Airport *Link*

Request for Project Change

MAY 2008

Queensland
Government

Figure 3-16
Southern Ventilation Station and Outlet - East Elevation View from Mann Park

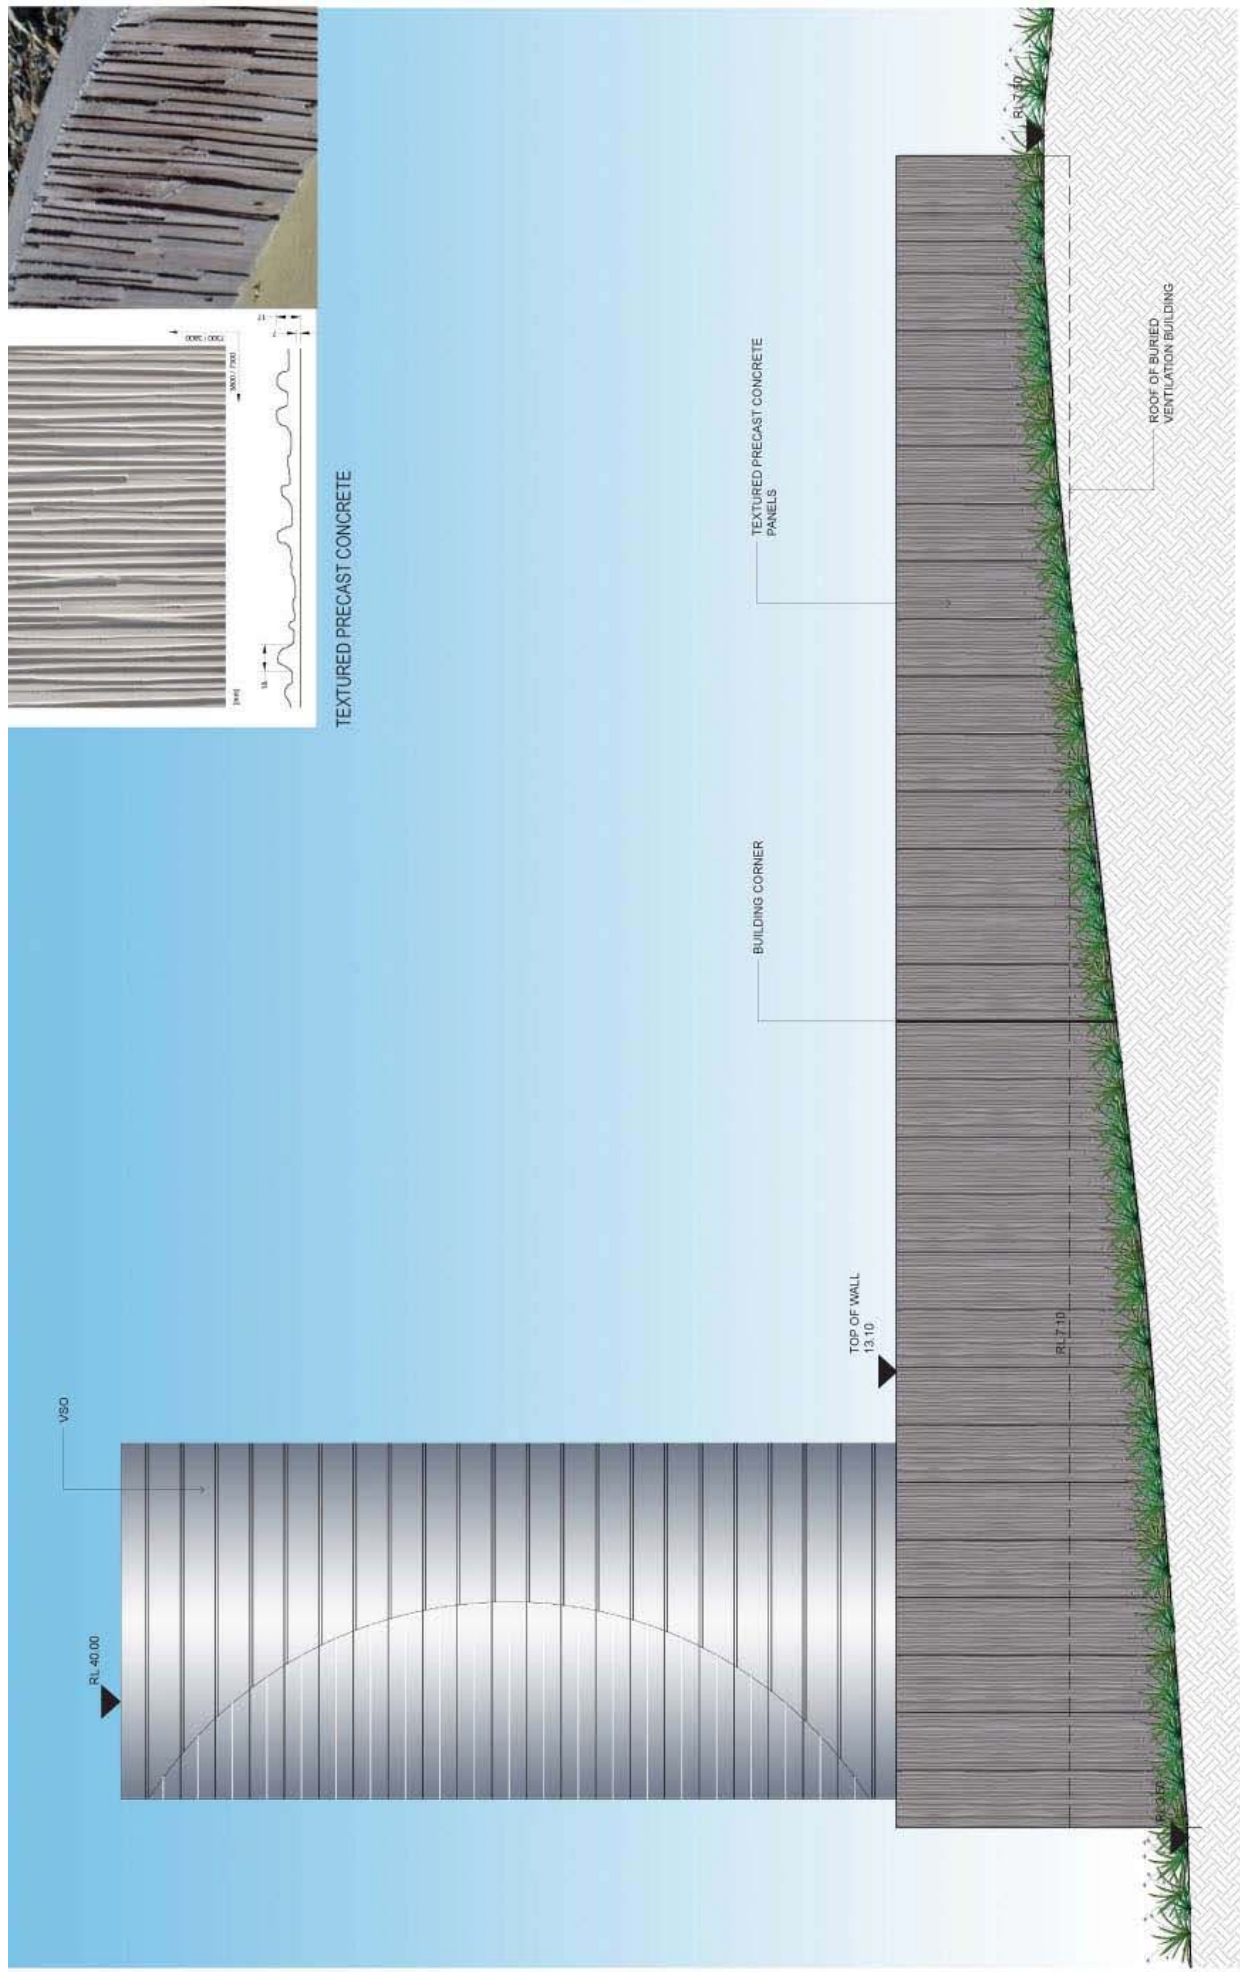
The proposed height of the ventilation outlet would be 36.5m above natural ground level at this location but approximately the same elevation as for the Reference Project (refer to **Figure 3-16**). The ventilation outlet has been structurally designed to be extended an additional 10m in the future, if required to remain clear above the heights of adjacent buildings. Development controls on the heights of adjacent buildings would be required to maintain the operational efficiency of the ventilation outlet in this location.

Figure 3-17

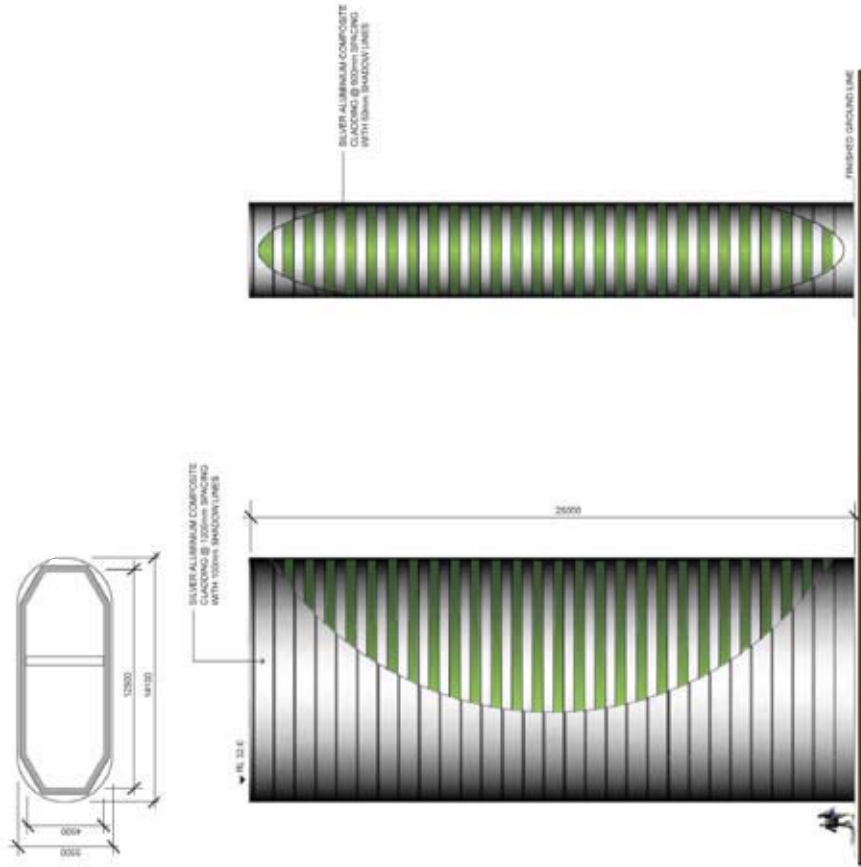
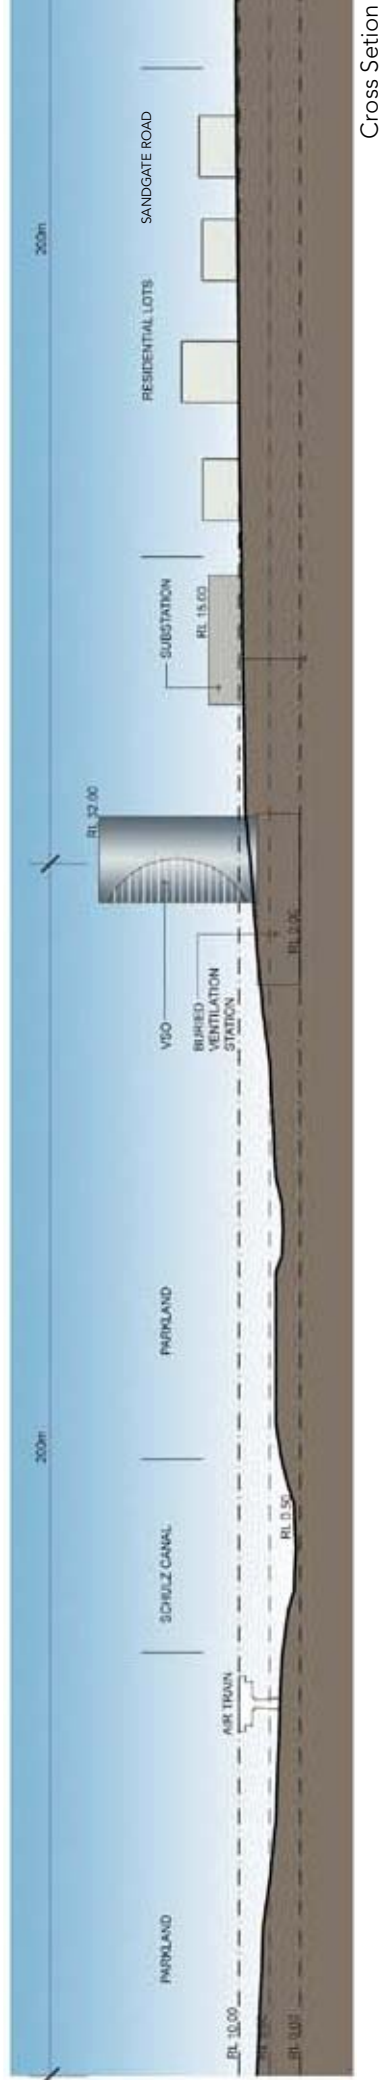
The Kedron ventilation station would be moved to the north of the DES building. The height of the proposed ventilation outlet would be 35m, being 11m higher than the ventilation station rooftop. The ventilation outlet has been structurally designed to be extended an additional 5m in the future, if necessary. Indicative elevations of the Kedron ventilation station from the south and from the east are provided in **Figure 3-17**.

Figure 4-5
Windsor Worksites and Workforce Parking

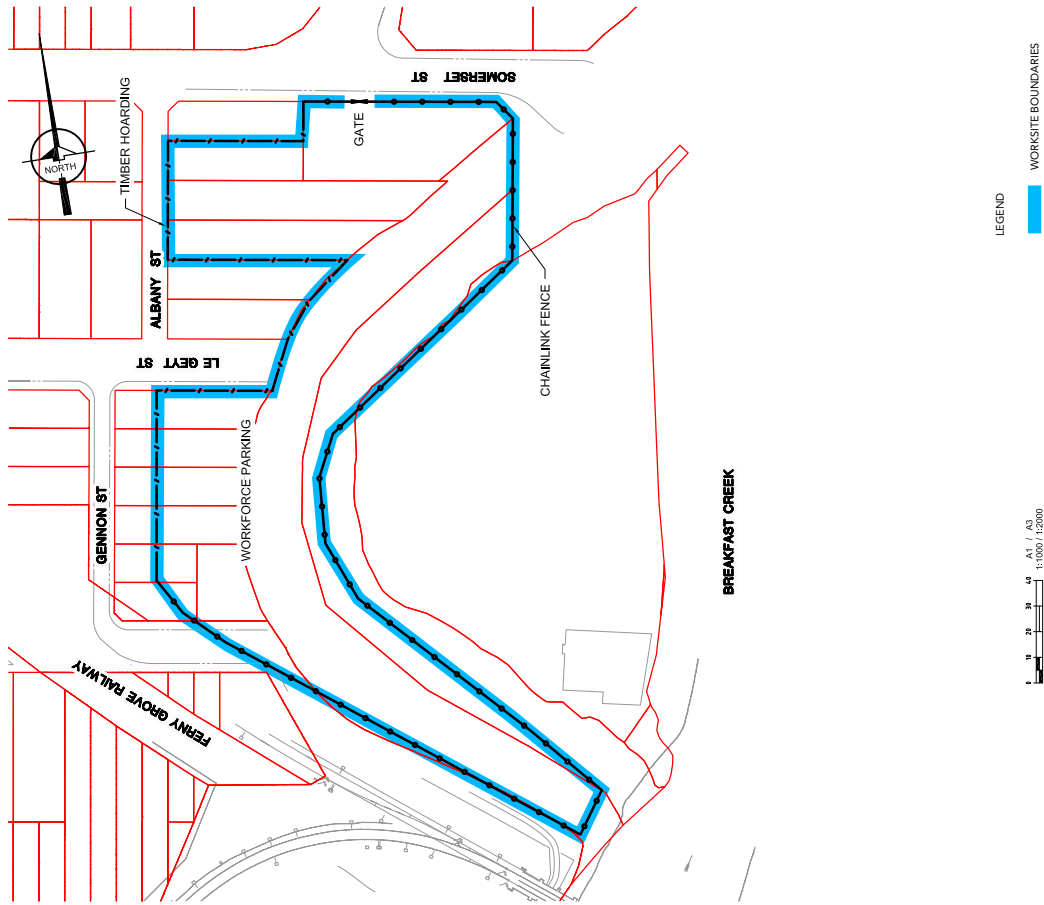
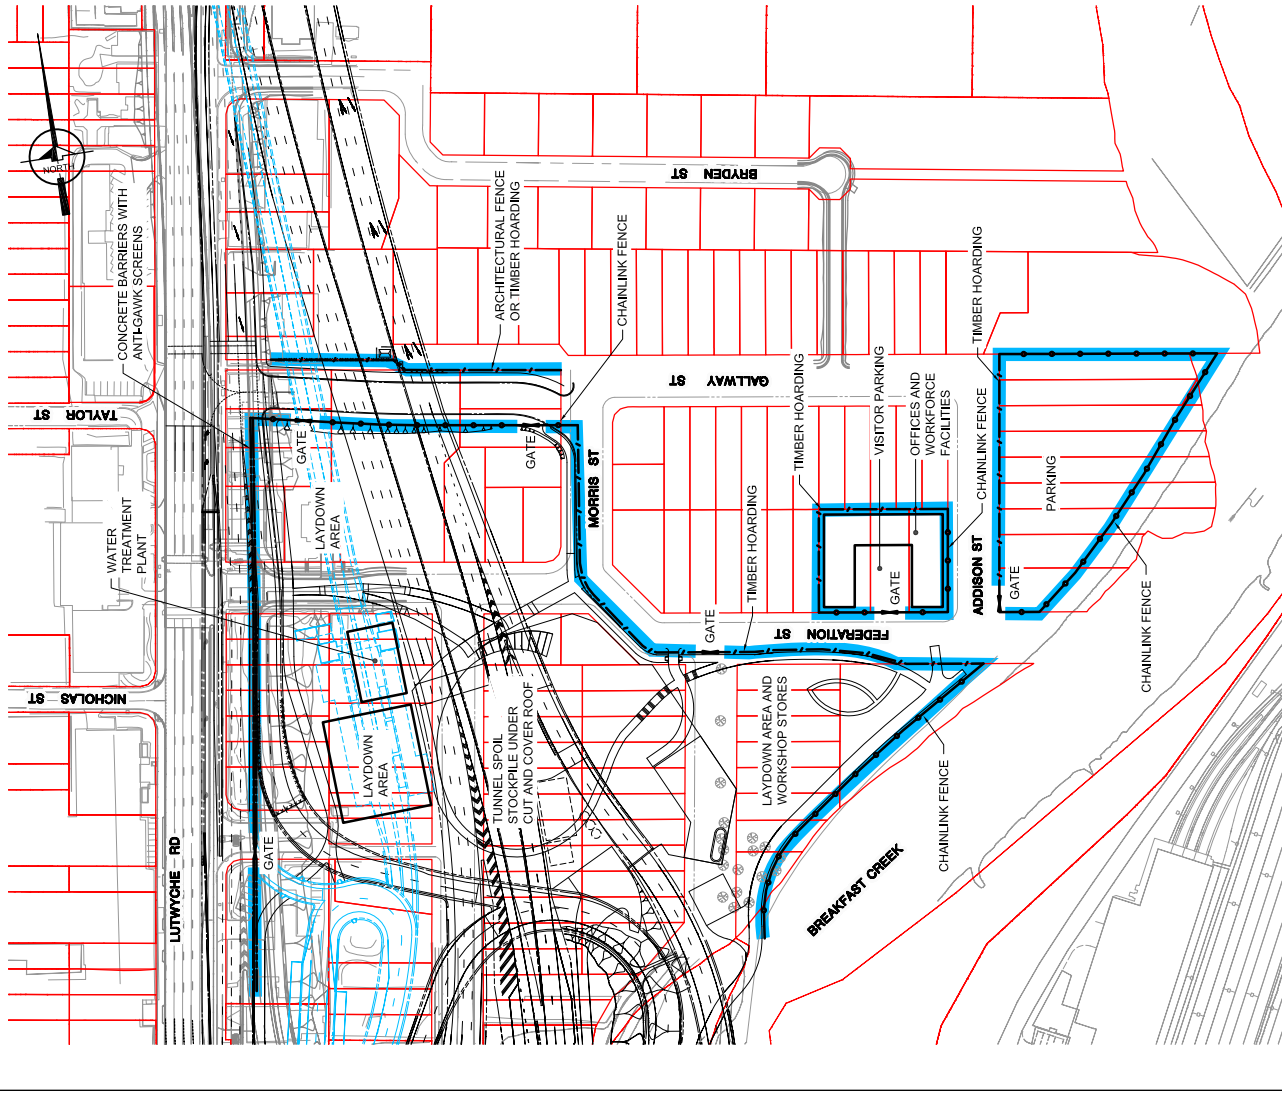
- expansion of the Windsor worksite, extending between Federation Street and Gallway Street, west of Morris street in order to provide suitable grades for the cut and cover tunnels necessary to construct the Lutwyche Road off-ramp (south-bound);

- additional worksites in Windsor, on the western side of Bowen Bridge Road south of Northey Street, to provide for the construction of the Bowen Bridge Road on-ramp (north-bound). These worksites would be shared with the Northern Busway to provide for Northern Busway bridging of Lutwyche Road;

The southern worksite at Windsor East would be expanded from that described in the Reference Project to include land between Federation Street and Gallway Street and east to Morris Street. The worksite would also be expanded as shown on **Figure 4-5** to include:

Figure 4-6
Lutwyche Road Worksite

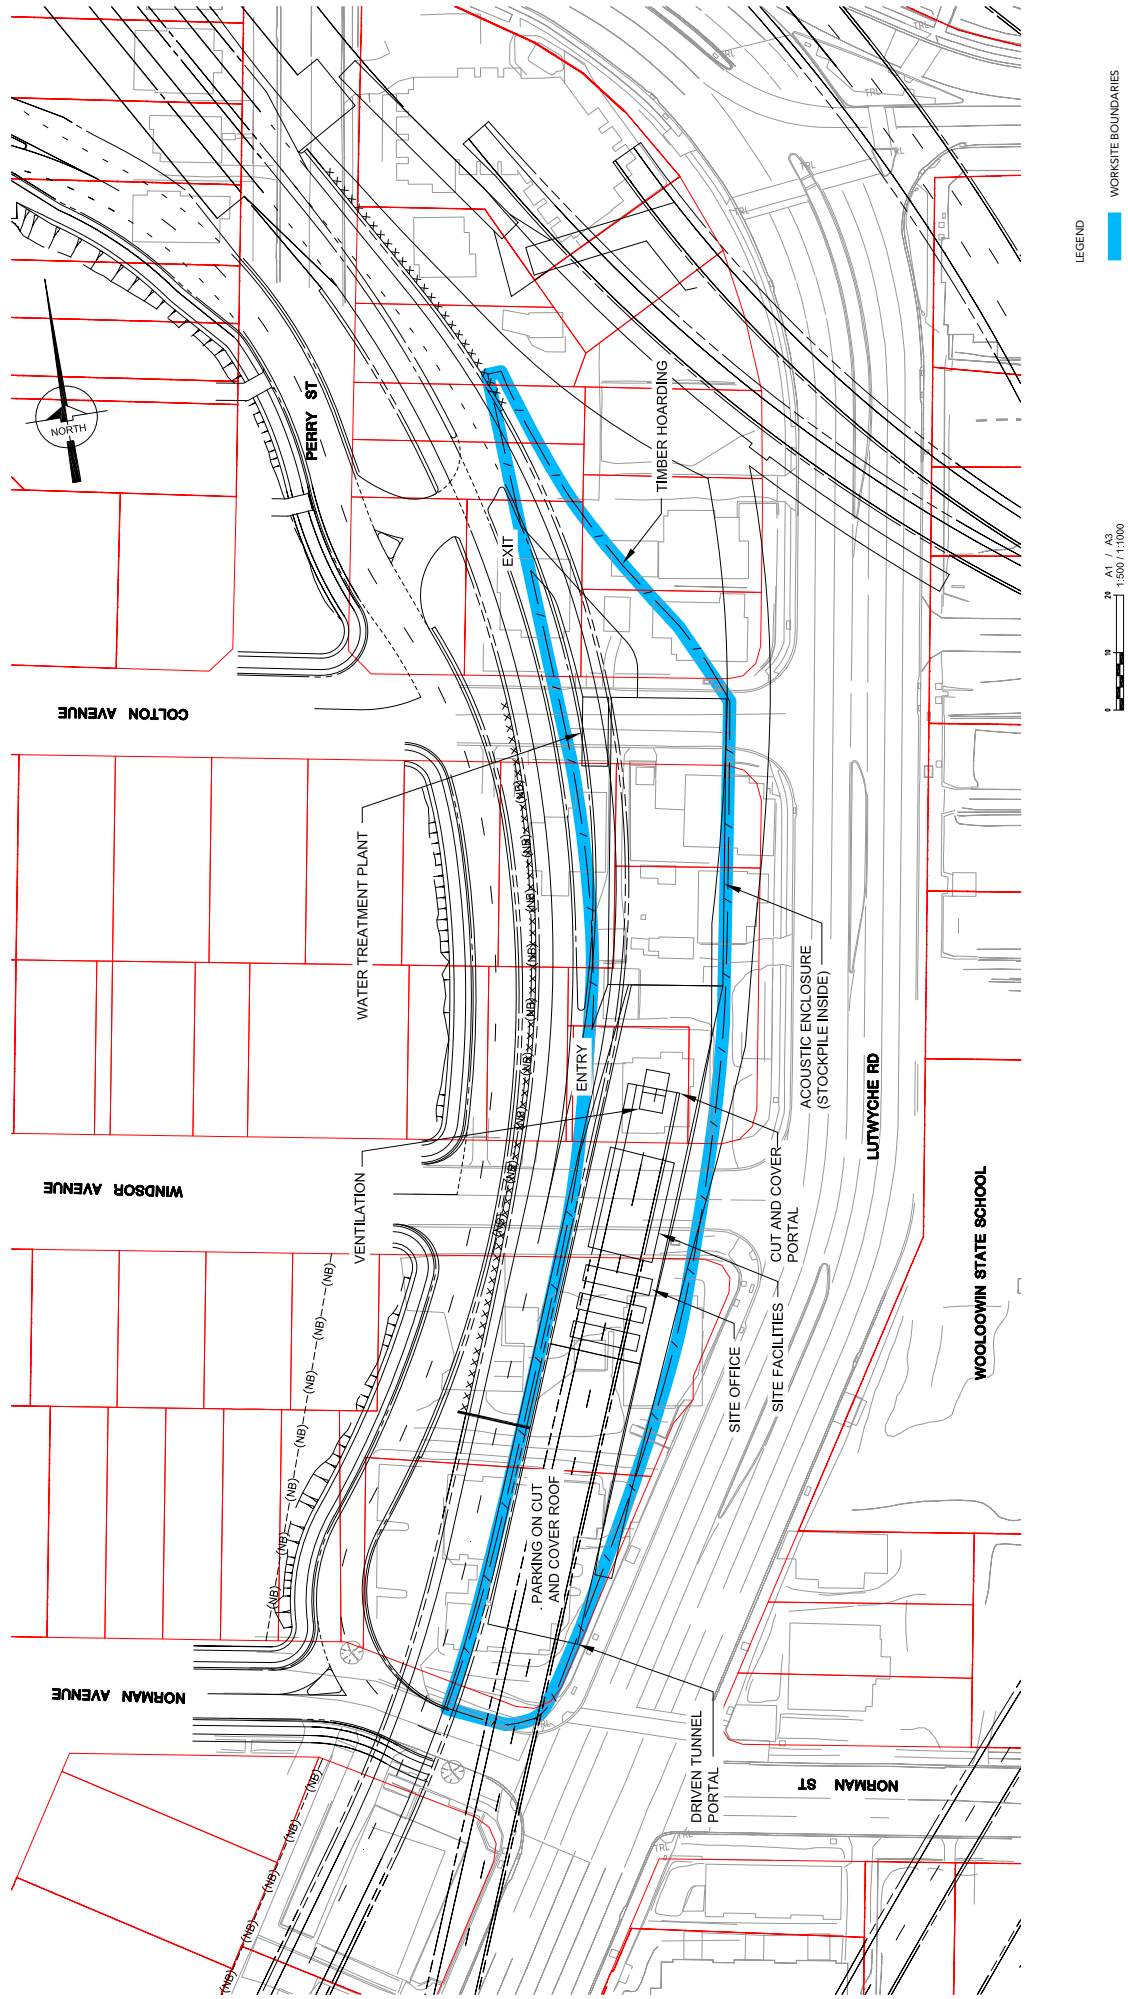
The revised design of the mainline tunnels under Lutwyche allows for the reduction in size of the Norman Avenue to Colton Avenue worksite (**Figure 4-6**) compared with the Reference Project. The Changed Project no longer requires the worksite to be within Lutwyche Road and, as a consequence, the worksite and associated facilities, including spoil handling within the acoustic shed, would be on the western side of Lutwyche Road between Norman Avenue and Perry Street. This worksite is required for the construction of the Airport Link off-ramp (north-bound) and transition structure. The portal to the tunnel off-ramp would be relocated north of the intersection of Norman Avenue with Lutwyche Road, and would be within the worksite. There would be no cut and cover works south of Norman Avenue or within Lutwyche Road as proposed in the Reference Project. Truck access to this worksite would be from Lutwyche Road.
